**STAFF REPORT – DESIGN REVIEW E**  
**FINDINGS AND RECOMMENDATION**

FILE NUMBER: DRE/SD/TR 17-26000291

PROPOSAL: Type III Design Review E for the construction of 7 single-family attached row houses with associated site improvements, a Type II Subdivision to create seven lots, and Type II Tree Removal.

*Fire Flow Requirements:*

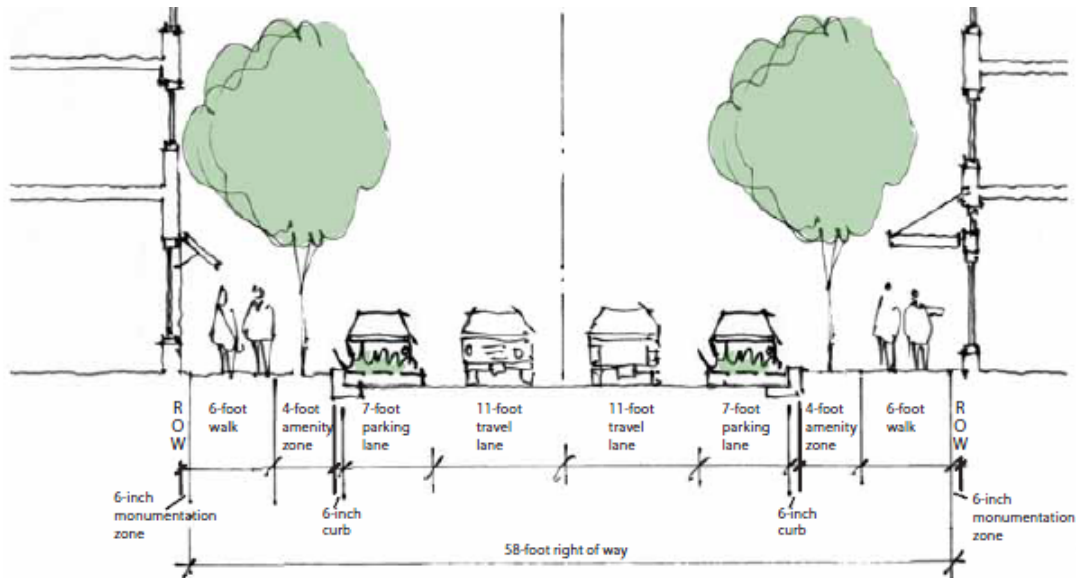
The Water Division has modeled fire flow conditions at an existing hydrant along the site frontage. This model shows that there is 1,800 gallons per minute (gpm) available with a residual pressure of 50 psi.

Fire flow requirements for the proposed project will be determined by the Fire Department and not by Development Engineering. Only the Fire Marshal or the Building Official can reduce or increase these requirements.

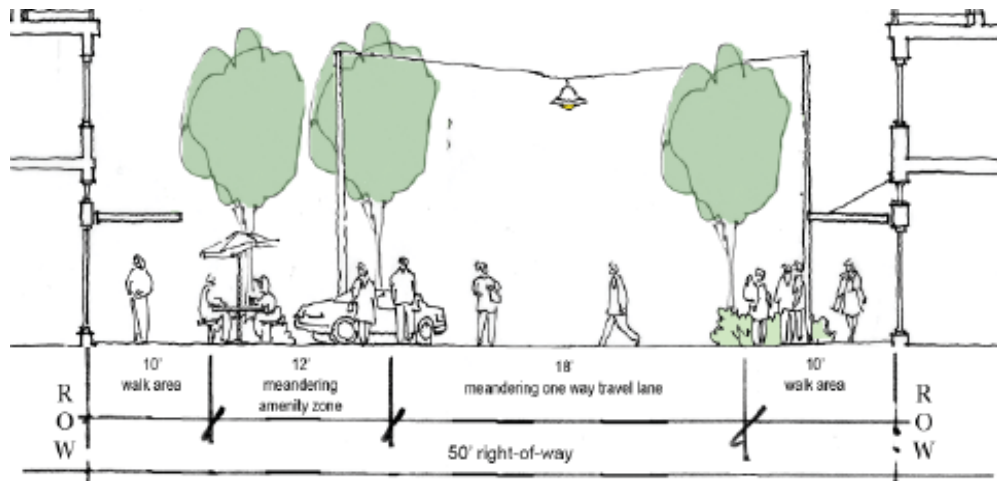
**NE 4<sup>th</sup> Street** is classified as a Downtown Urban Commercial Street. The standard right of way width and improvements are shown in the cross section below. As proposed, 4 feet of right-of-way shall be dedicated along the site's NE 4<sup>th</sup> Street frontage to meet current standards. Half street improvements as shown in the cross section are also needed to comply with the standard. These improvements shall include; widening the pavement to 18-feet from centerline, installing a 6-inch curb, a 4-foot planter strip, and a 6-foot sidewalk.

**NE Beech Avenue** is classified as a Green Shared Street. The standard right of way width and improvements are shown in the cross section below. As proposed, 5 feet of right-of-way shall be dedicated along the site's NE Beech Avenue frontage to meet current standard. An additional 5-foot walk zone shall be provided along the site's Beech Street frontage. The walk zone could either be an extension of the existing pavers or a concrete sidewalk. Both options would need to be at the same elevation as the existing road and walkway.
